Wylfa Newydd Development Consent Order

Written Representation on Coastal Processes and Geomorphology

Professor Kenneth Pye ScD PhD MA CGeol FGS

27 November 2018

Figure 7. Enlargement of part of Figure 5 (Porth-y-pistyll area)

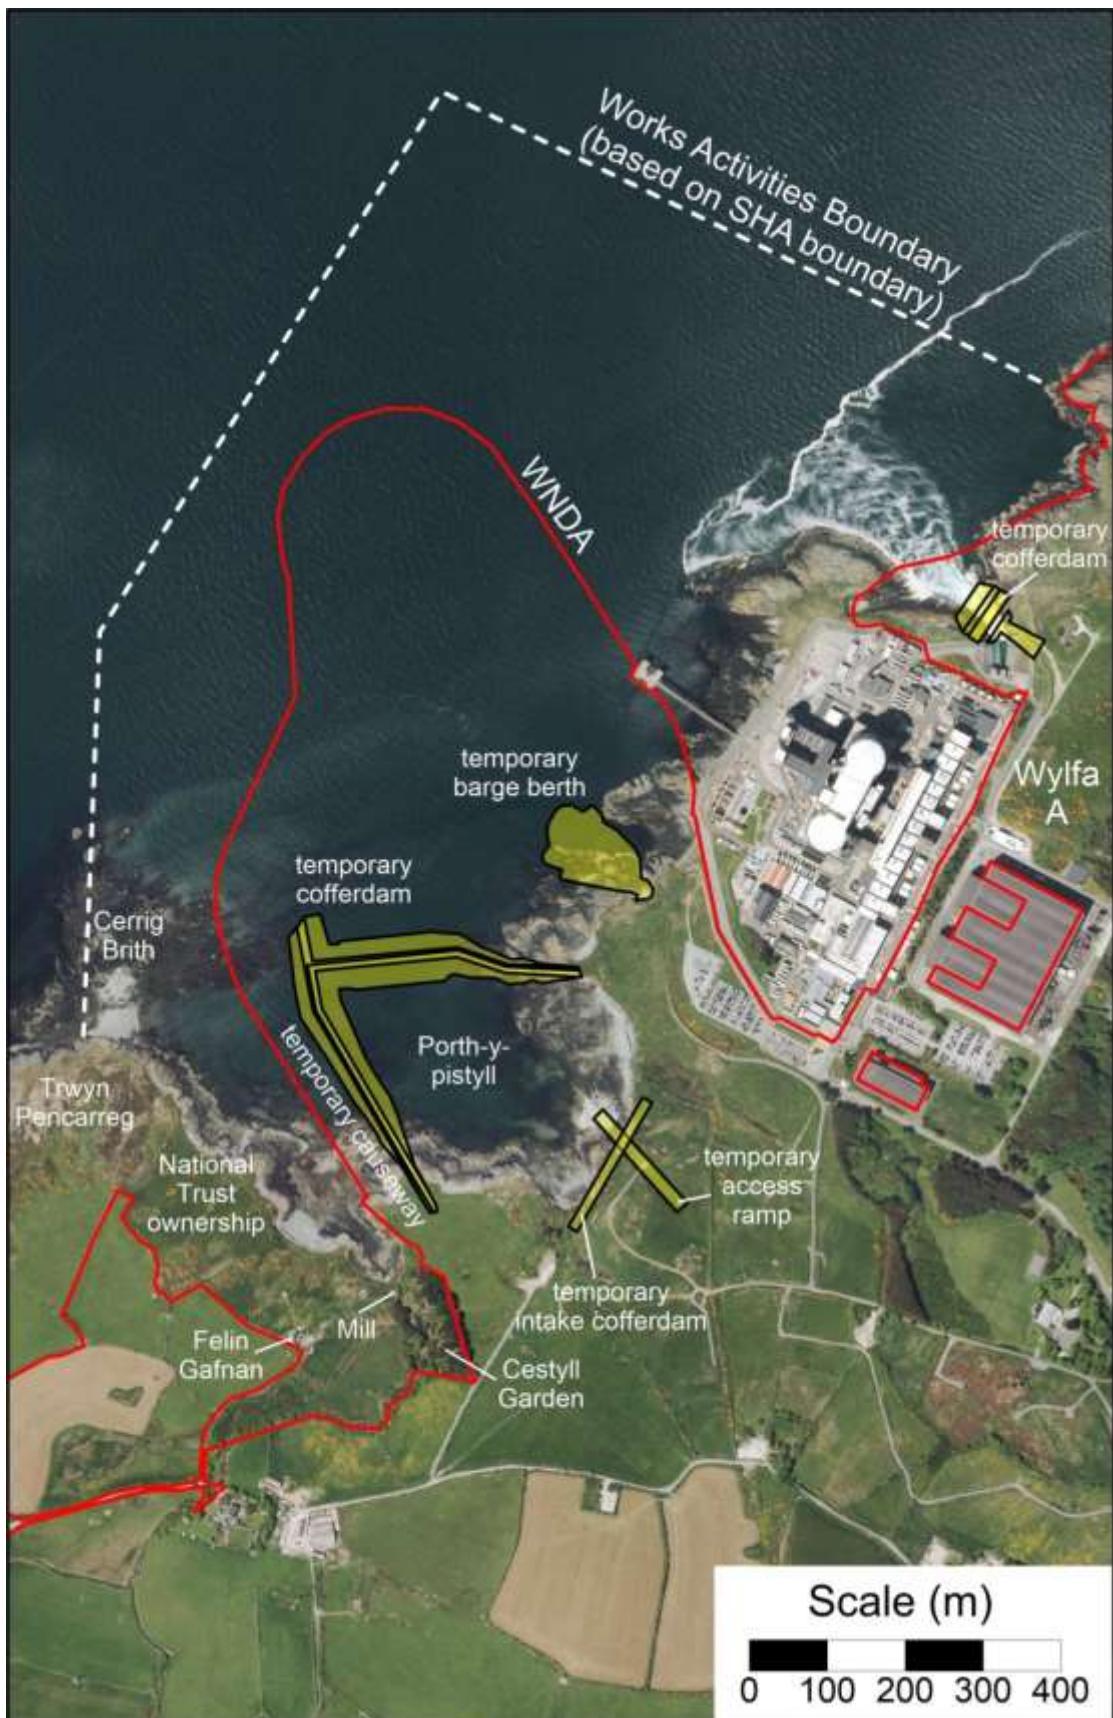
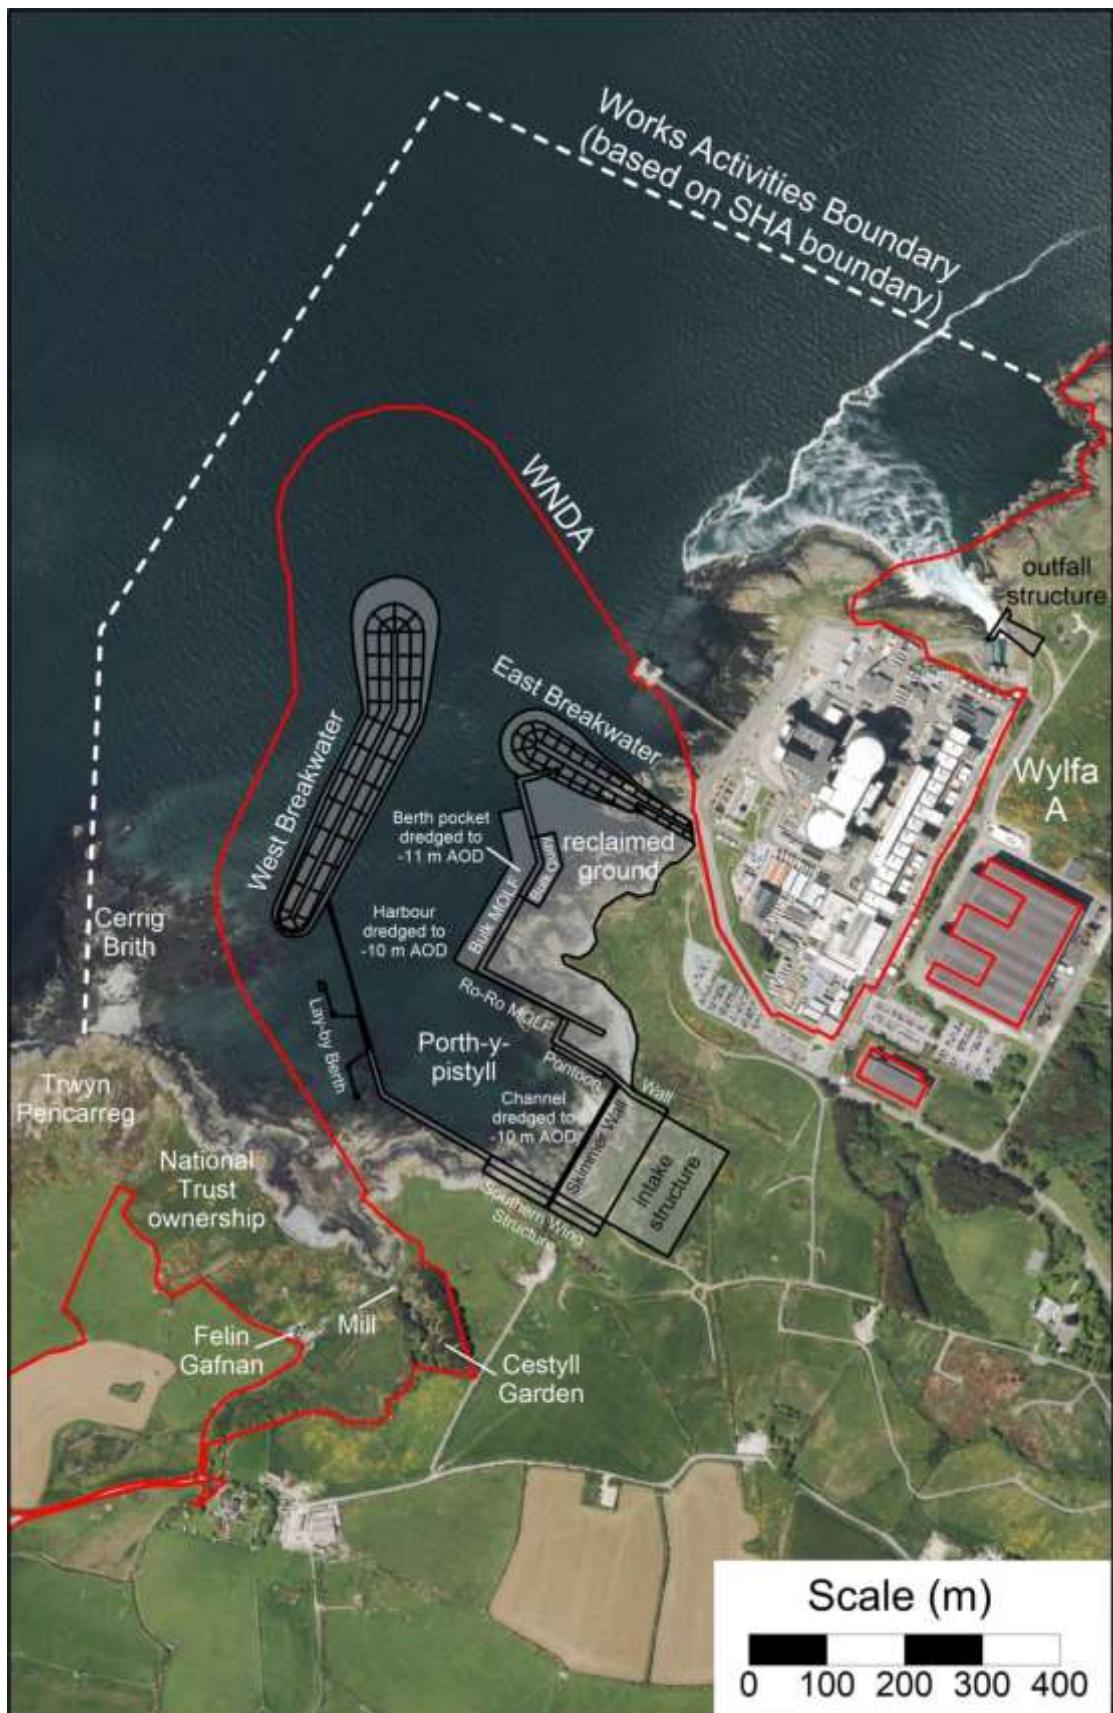
19 The possibility that construction of the harbour structures, particularly the western breakwater (Figure 7), could cause a significant increase in nearshore wave heights within Cemlyn Bay due to wave reflection, refraction and greater focussing within the Bay has been considered in the ES (APP-131) but judged not to be significant based largely on the results of the wave and hydrodynamic modelling. However, as advised to Horizon during the audit of the hydrodynamic model by ABPmer in 2015 and 2016, bed shear stress in itself is not sufficient to characterize the potential for sediment movement and morphological change. Similarly, significant wave height alone does not fully characterize wave conditions or the potential for wave-induced sediment transport and morphological change. There are dangers in placing over-reliance on the results of numerical modelling, the outputs from which depend heavily of the model assumptions and input parameters, and especially in drawing broad conclusions about likely medium and long-term morphological change from short term results which consider only a small number of model output parameters. The HNP assessments make only limited attempt to integrate the modelling results with other information, and do not provide sufficient consideration of how changes in modelled significant wave height and bed shear stress may affect sediment erosion and longer term evolution of coastal morphology.

22 The proposed marine works include the construction of a breakwater, approximately 400 m in length, which will be emergent at high tide. The southern two-thirds of the breakwater will have an approximate SSW-NNE orientation while the northern third will have an approximate S-N orientation (Figure 7). Consequently, refracted westerly and northwesterly waves will experience reflection off the breakwater, with the reflected waves being directed towards Cemlyn Bay. **The combination of reflected waves and refracted incident waves is likely to lead to increased wave focussing and greater significant wave heights within Cemlyn Bay.**

Figure 12. Significant wave height and wave direction with assumed model boundary input conditions of $H_s = 4.0$ m, $T_p = 8$ s, and $Wdir$ N360°E (northeast), indicated by MIKE 21 modelling. (from Pye & Blott, 2018a)

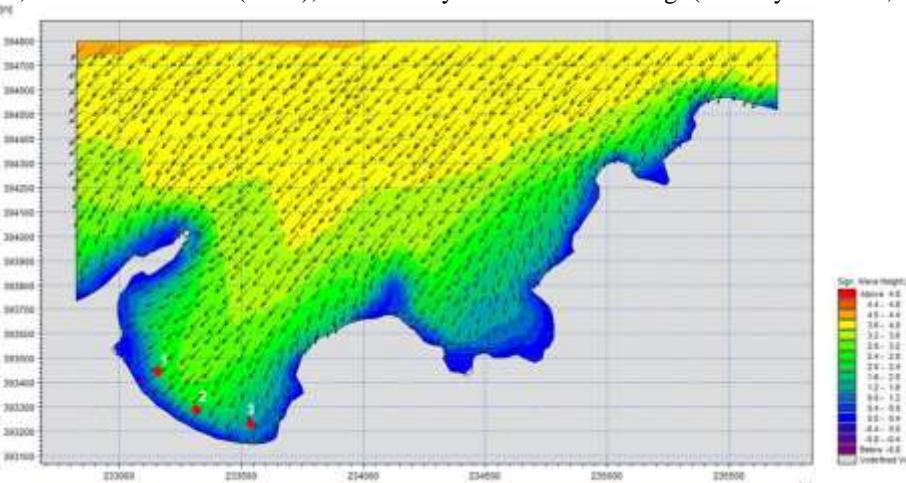
21 The offshore wave climate near the north Anglesey coast is dominated by waves from the southwest and west, but waves from the northwest and from east-northeast are also important (Figure 9). At offshore point 1464, approximately 5.3 km NNE of Cemlyn Bay, the 99th percentile hind-cast significant wave height (H_s) in the period 1980-2016 was 2.96 m and the 99th percentile hind-cast wave period (T_z) was 5.67 seconds (Pye & Blott, 2018a). Waves from the west northwest, north and northeast are particularly important in terms of their impact on the Cemlyn Bay shoreline. Under northwesterly wave conditions, waves impact directly on Traeth Pencarreg and Cerrig Brith. Westerly waves are also refracted around Trywn Cemlyn and impact significantly on the eastern Cemlyn Bay shoreline (Figure 10). Waves from a northerly direction also have an important impact on these sections of the shore, also extending further to the northwest along Esgair Cemlyn (Figure 11). Waves from the northeast, which travel directly down the axis of Cemlyn Bay, impact on most of the Esgair Gemlyn shoreline (Figure 12).

Figure 13. Difference in H_s for the fully-built (with cofferdam) 2023 scenario minus baseline, Winter 99th % wave from the NW (300°) (from Jacobs 2018)

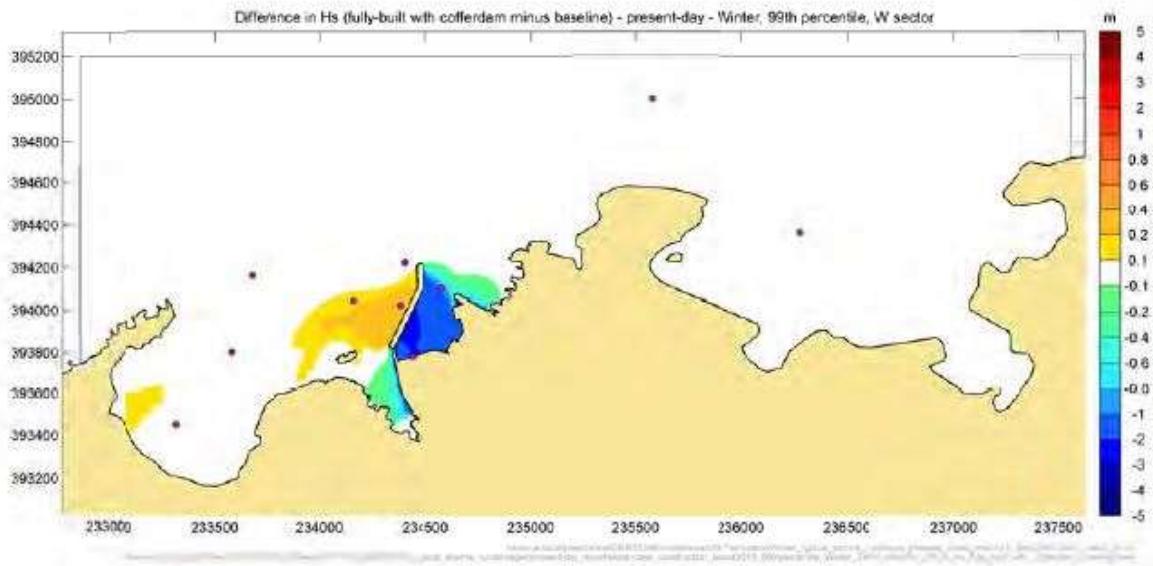
25. Further coupled NW 99%ile wave and tidal modelling undertaken after DCO-submission, summarized in Jacobs Technical Memorandum 60PO80AGGE0TM002 (dated 4th October 2018) and presented to the NT and other NGOs at an ecological and marine issues consultation meeting on 11 October 2018, shows that for the 2023 fully built scenario there could be an increase in significant wave height of 10 - 20 cm in the inner part of Cemlyn Bay, close to the lowest and most vulnerable part of the shingle ridge, located between the tern islands and the inlet entrance (Figure 13). For the 2087 fully built ‘with climate change’ scenario the predicted increase in significant wave height in this area is even larger (Figure 14).

26. **The implications of an increase in wave run-up and overtopping of the shingle ridge associated with an increase in significant wave height of up to 20 cm are not considered in the Horizon documents referred to above. The risk of breaching of the ridge crest due to erosion of the upper beach face and seaward side of the crest also has not been considered.**
